Re: An Application for a Certificate of Public Convenience and Necessity for the Benvoulin Substation Project No. 3698529

INFORMATION REQUEST NO: 2

APPLICATION NAME: CPCN Application for the Benvoulin Substation Project

BCUC Diagram A45.2

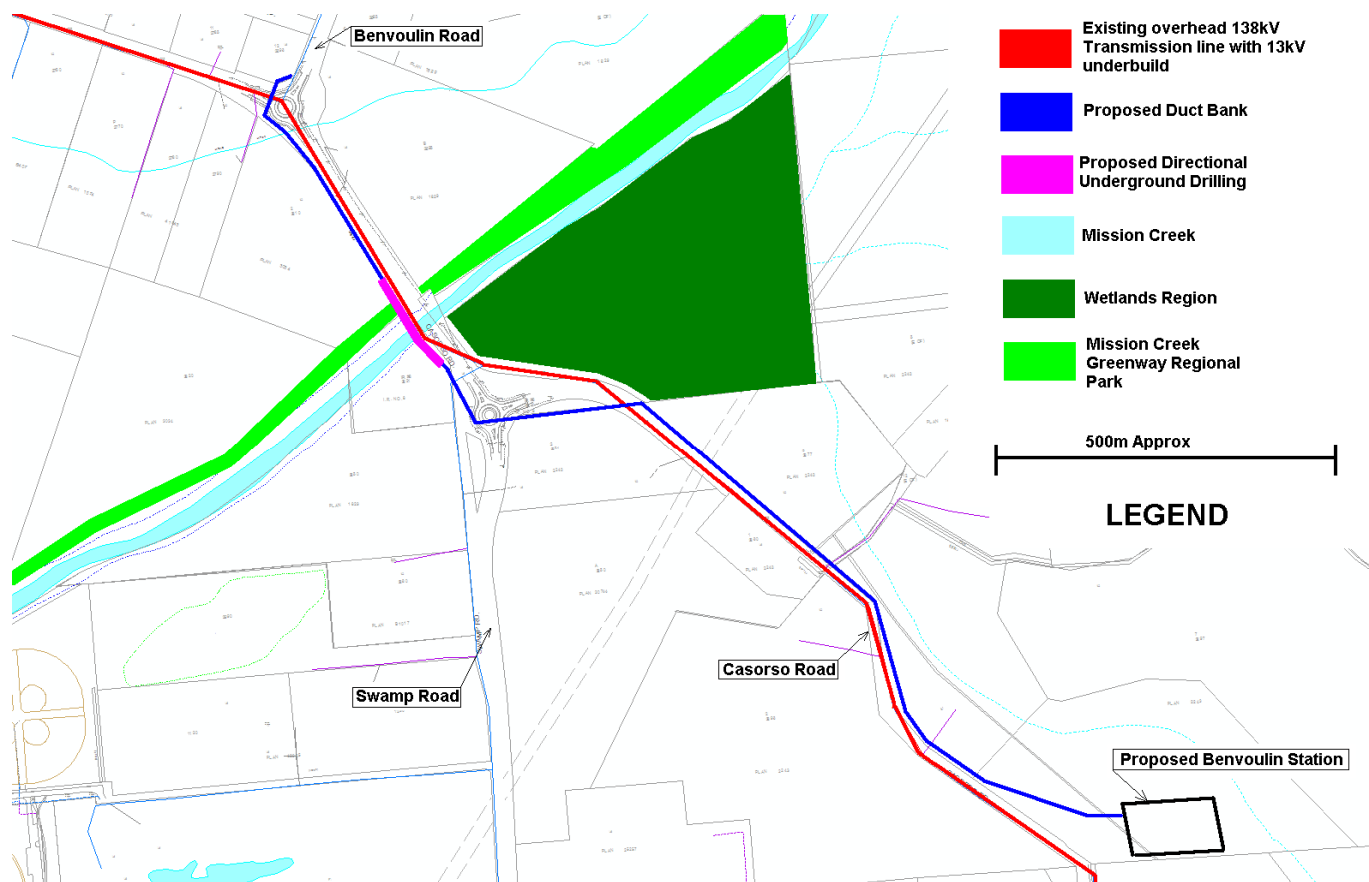
Q45.2 Further to BCUC Diagram A12.1, please provide a diagram that shows the area covered by the Mission Creek Greenway Regional Park and the wetlands area near the junction of Benvoulin and Casorso Roads. The diagram should also show the existing 138/13 kV routing, the proposed underground routing, and the section that will be installed using directional drilling.

A45.2 The requested information is shown below in BCUC Diagram A45.2.

BCUC Diagram A45.6

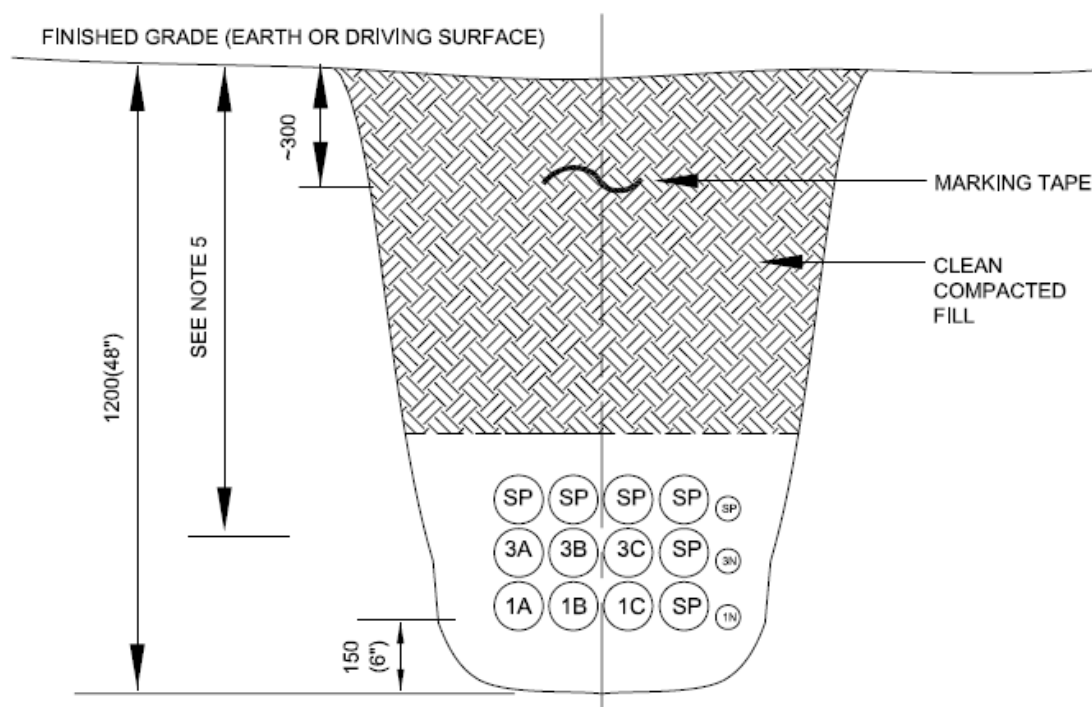
Q45.6 Please describe the method(s) of construction that will be used to install the other sections of the underground ducting.

A45.6 Conventional open trench construction will be employed. A typical cross section is shown below in BCUC Diagram A45.6

BCUC Figure A85.6: OTR Load vs Temperature

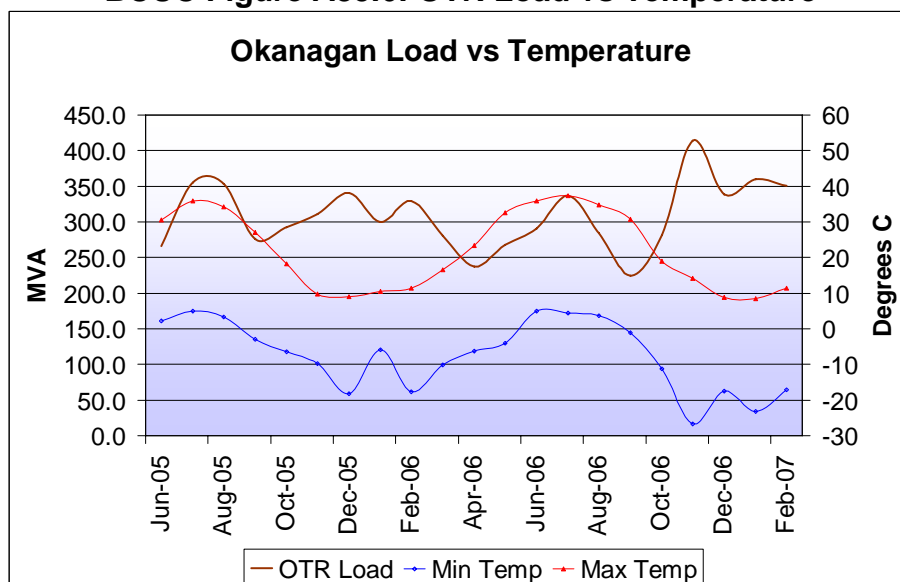
7 **Q48.3** **Based on current projections of economic growth, please revisit and**
8 **revise as necessary the load forecast that supports the need for a new**
9 **Benvoulin substation and clarify when the revisited information**
10 **indicates the substation will be required.**

- 2 • The load in the Kelowna region is sensitive to temperature. Temperature
3 extremes in the form of a hot summer or cold winter may have a greater
4 impact on loads than the current economic slowdown (see BCUC Figure
5 A85.6 below showing the Kelowna/Penticton region extracted from the
6 Okanagan Transmission Reinforcement (OTR) Project BCUC IR2.)

6							DRAWN BY			CONTROL BUILDING	
5							CHECKED BY				
4							APPROVED BY				
3											
2							<div></div>			DRAWING No.	REV.
1										317—GA(MOD)	
REV	DATE	BY	CHECKED	DESCRIPTION			APP.	DATE

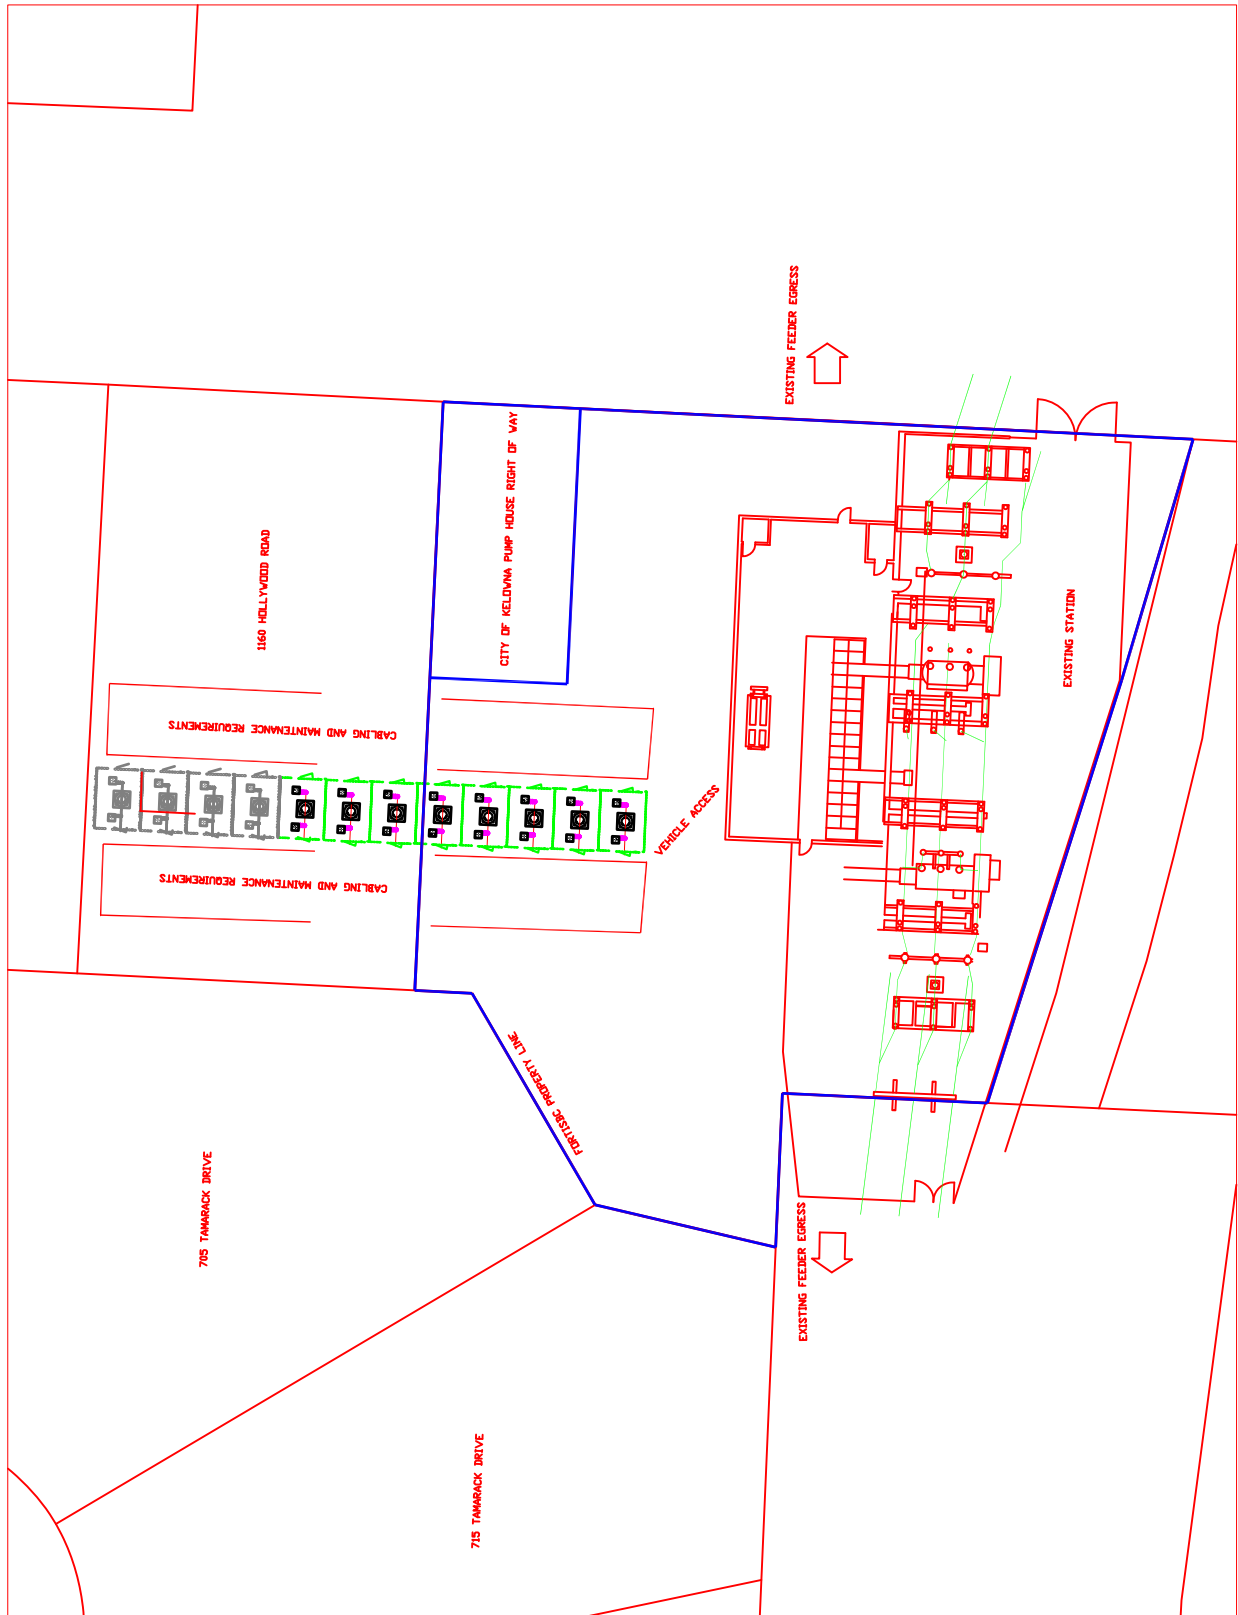
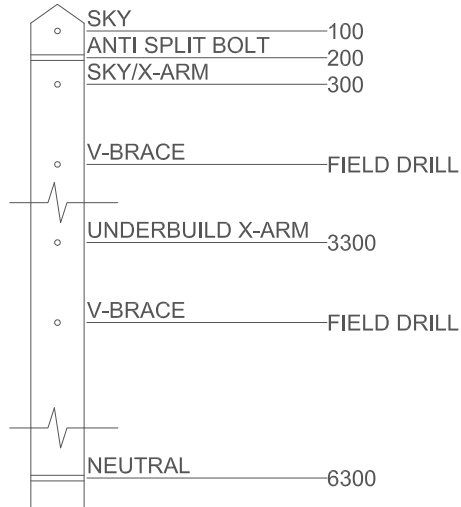
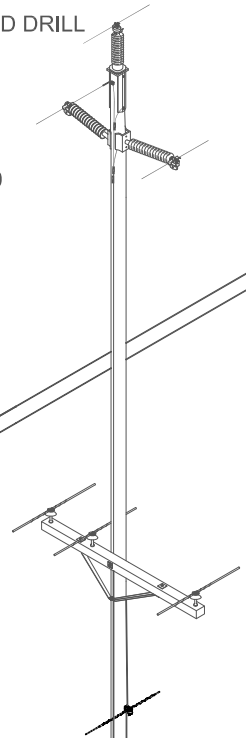
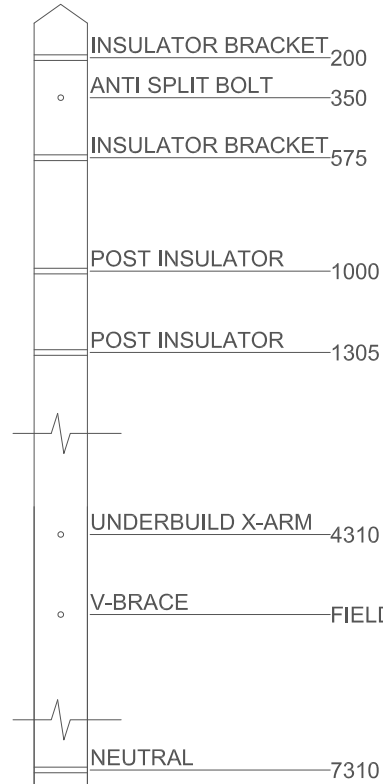
Q57.1 Please provide a drawing scale or dimensions for drawing no. 317-GA(mod), Rev. 0.

A57.1 The drawing is attached as BCUC Appendix A57.1.

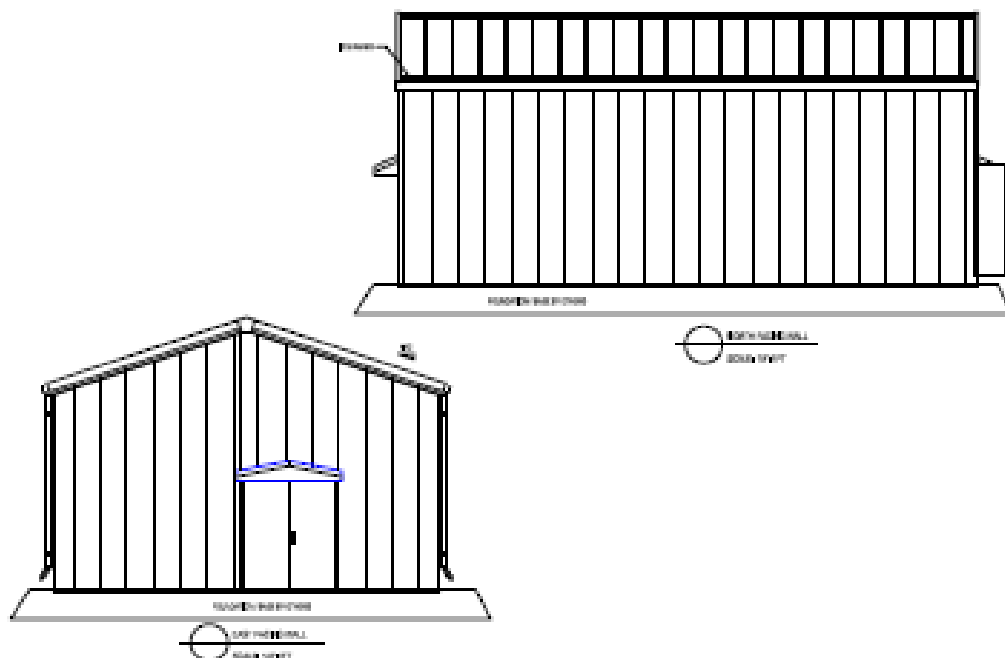
1 **Q2. Please provide a diagram and details of the location and configuration of**
2 **transmission lines as they enter and exit the Substation property, including**
3 **pole heights, space tolerances and the number of lines supported on each**
4 **power pole.**

5 A2. Please see Tantalus Appendix A2. Design to the level of detail requested has
6 not been completed, however the pole heights are expected to be consistent with
7 the existing structures at 70 feet for angle structures and 55 feet for tangent
8 structures. Likewise the number of lines overhead will remain the same as the
9 distribution component is proposed to be underground.
